Subject: Request for Proposal 2 - Changes to Backfill at Interior Retaining Walls

Project Name: Camden Rockport Middle School

Potential Change Order #007

Request for Proposal No. 002

OAK POINT ASSOCIATES
 SB503
 DRAWING NO. SB503
 SHEET NO. 74 OF 369

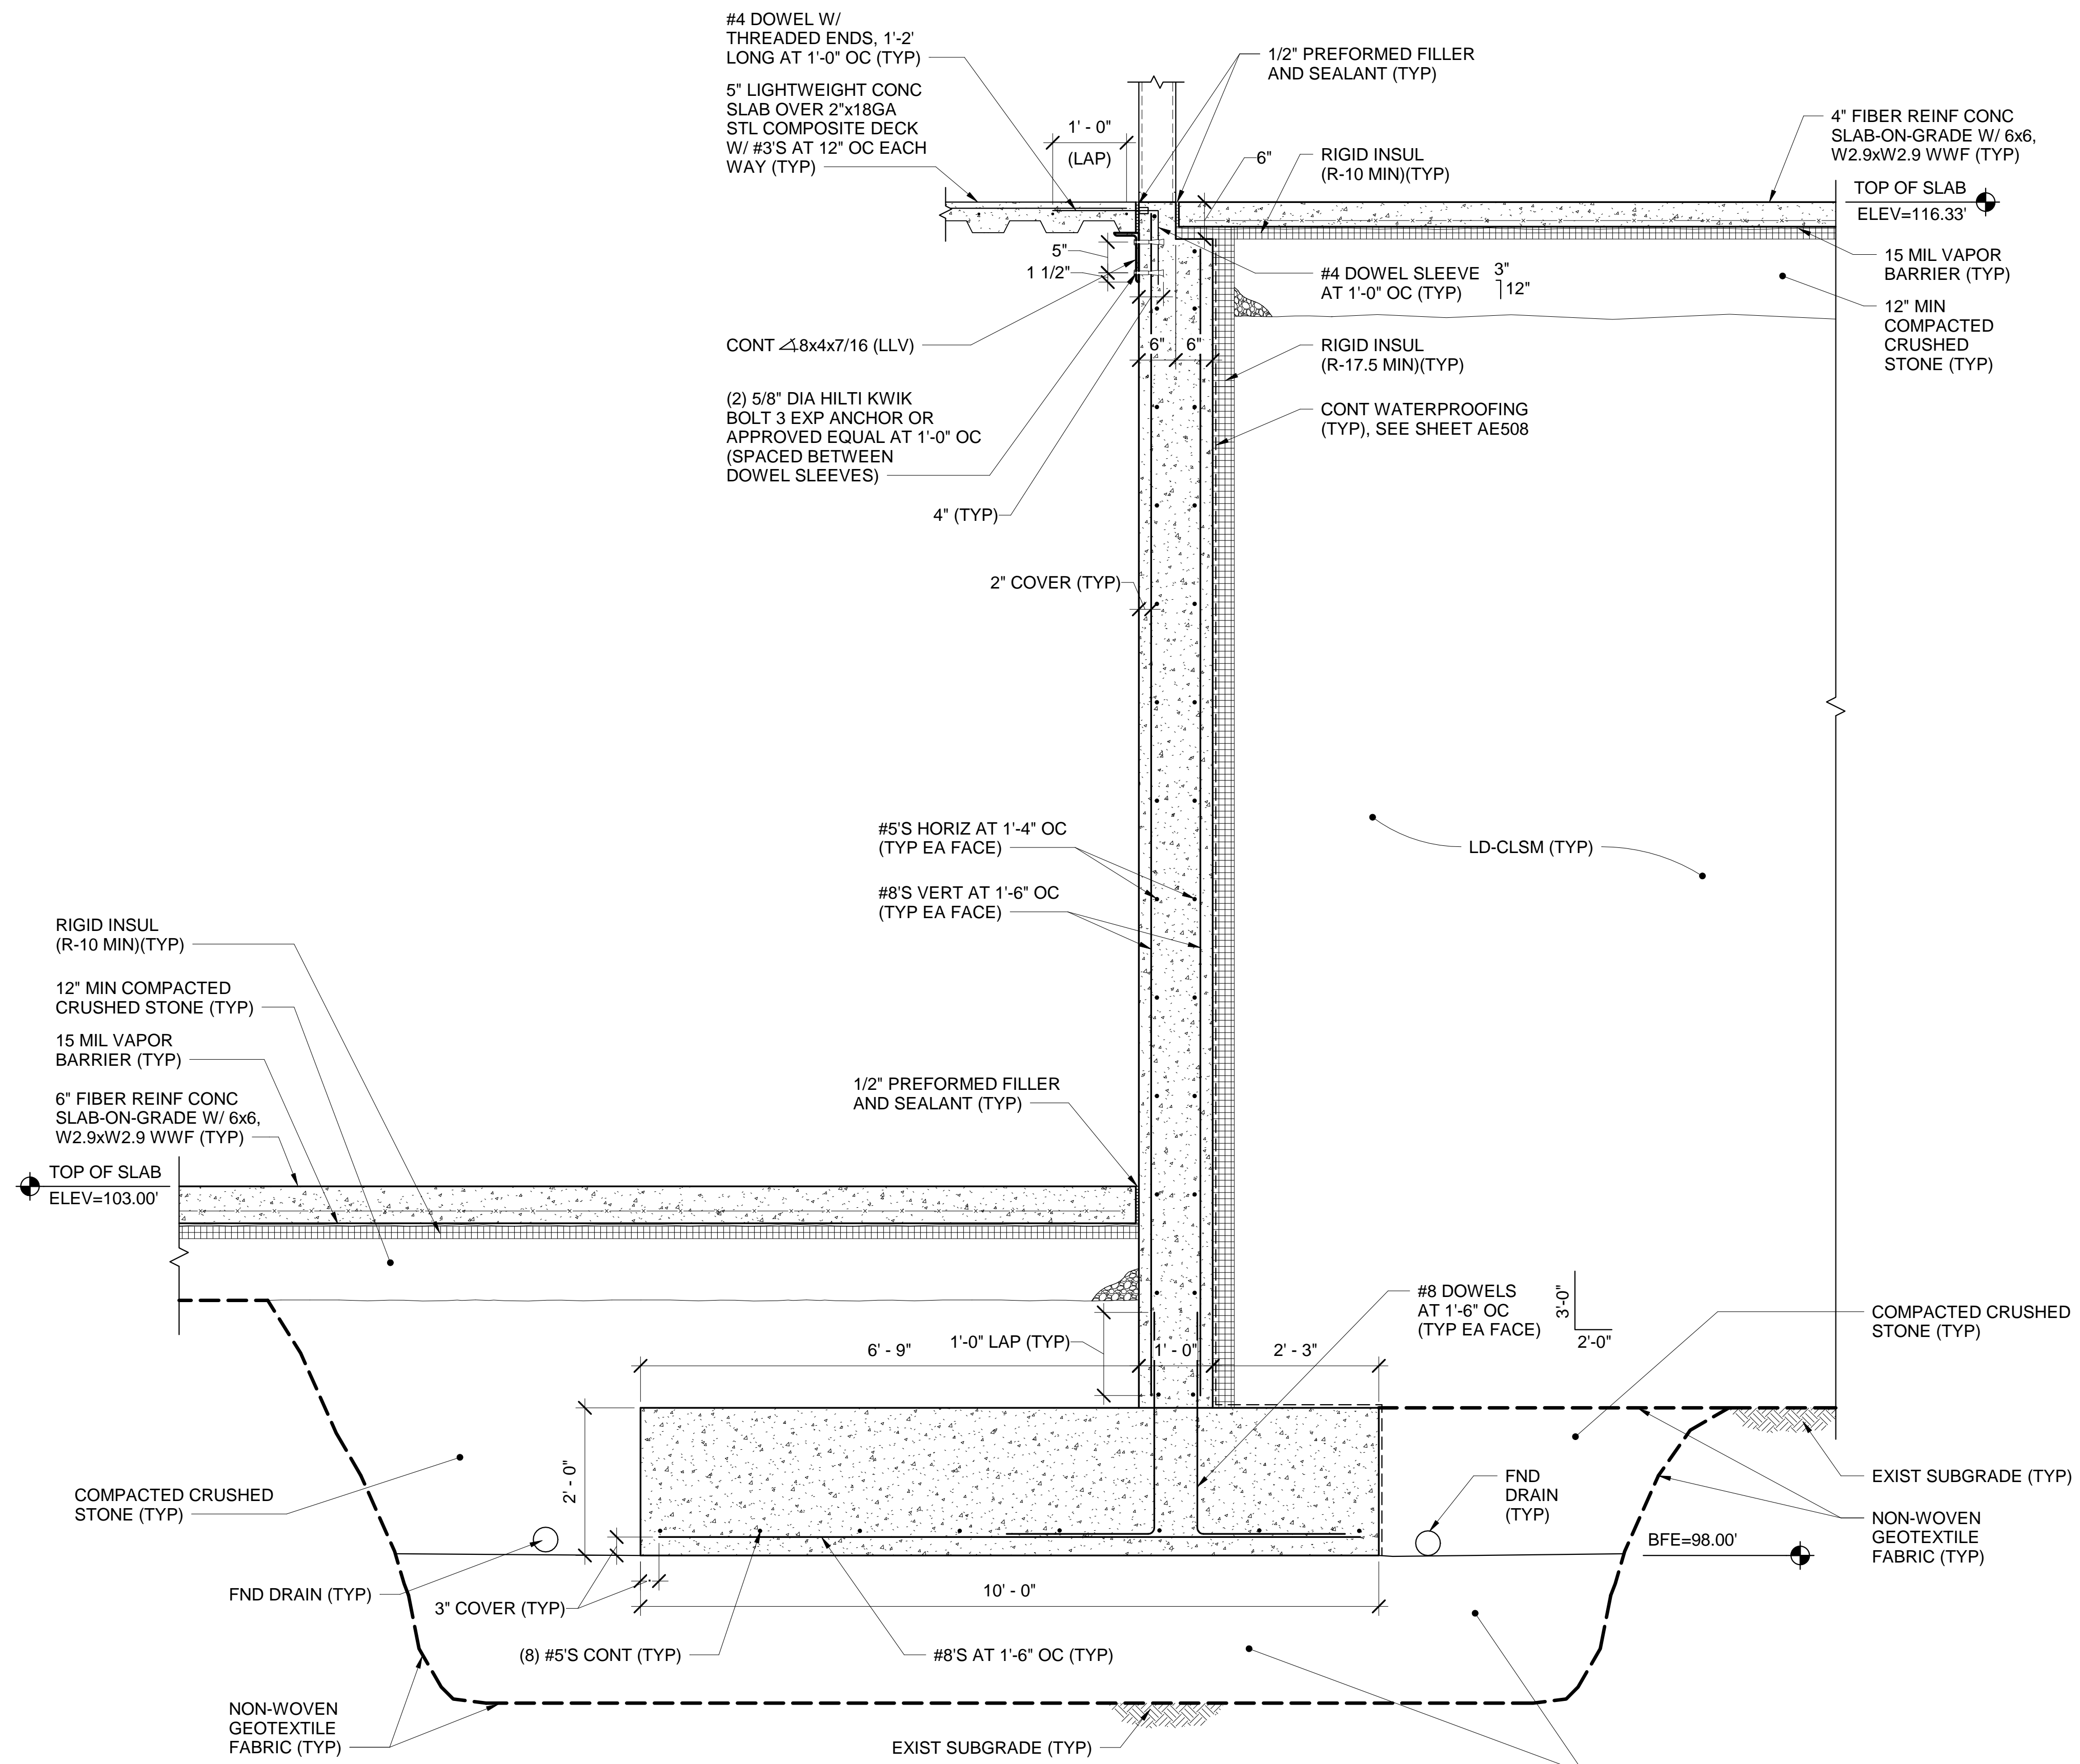
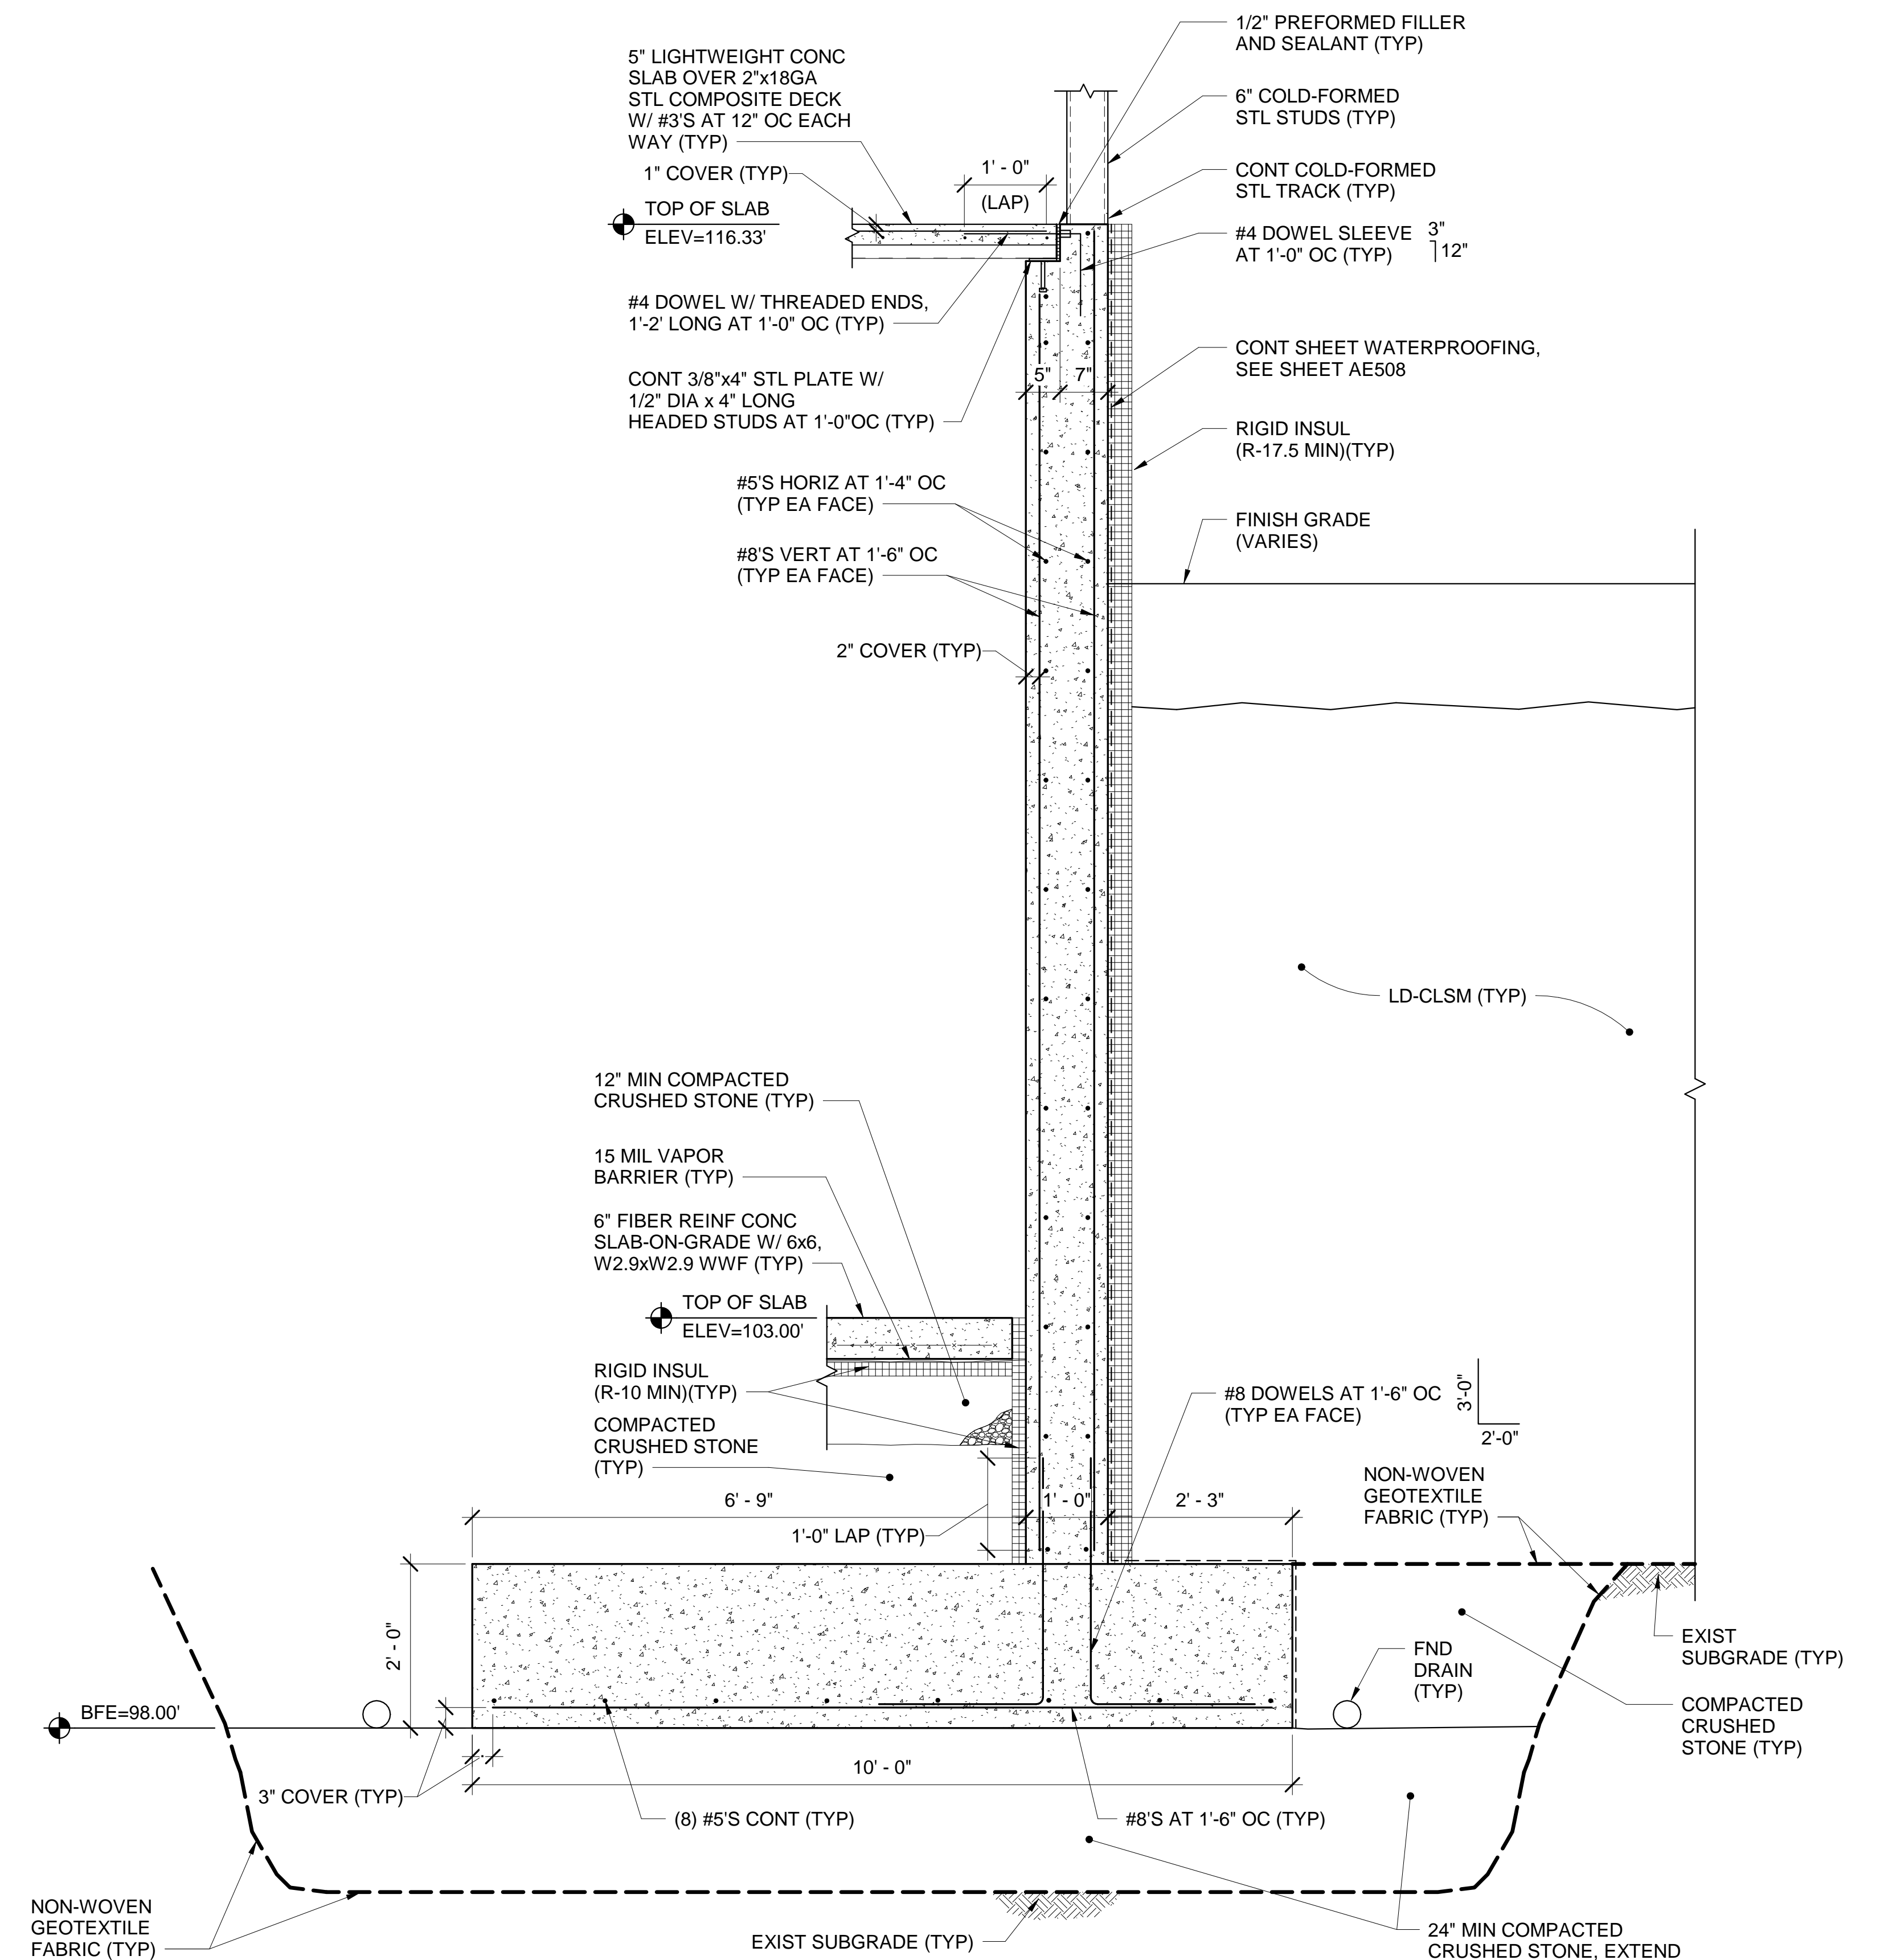
3. Revise reinforced concrete retaining wall indicated in detail 1/SB504.
4. Refer to attached drawings SB102 (**Revised 08-22-18**), SB503, SB503, SB504 and SB505 for modifications to foundation plans and details.
